Technical Service Bulletin

GROUP	NUMBER
RECALL	26-01-005G
DATE	MODEL(S)
JANUARY 2026	G90 (RS4)

SUBJECT: FALSE DETECTION OF VEHICLE WITH HIGHWAY DRIVE ASSIST ENABLED (RECALL 030G)

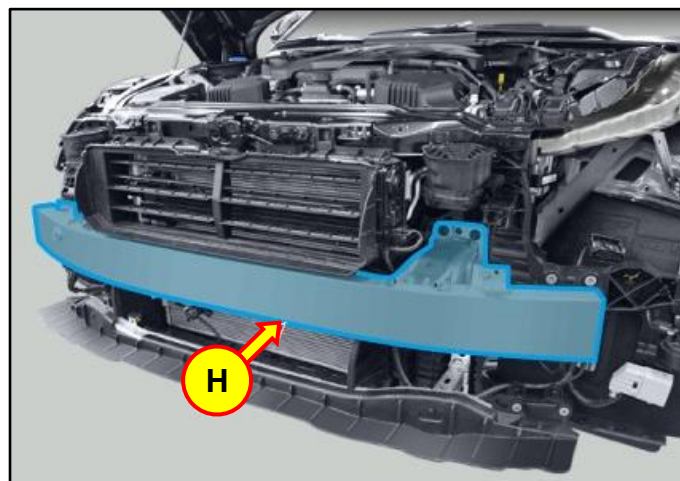
8. Remove the front bumper beam assembly (H), after removing the bolts and nuts.

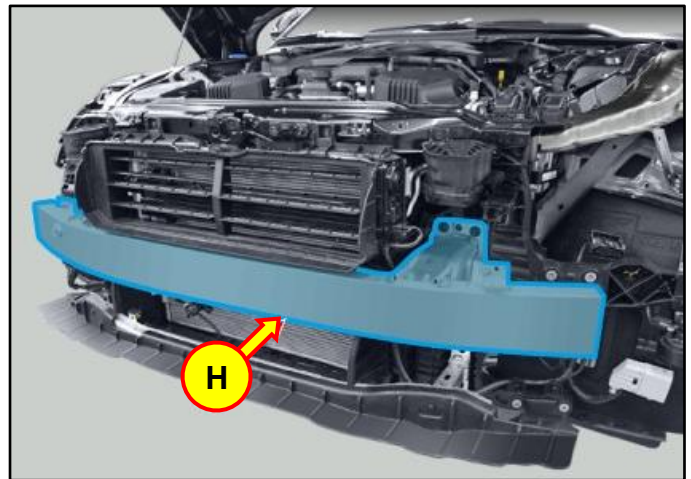
10. Install the new front bumper beam assembly (H).

Using the STUI camera function, take a photo of the new front bumper beam assembly showing the updated design change of the end caps.
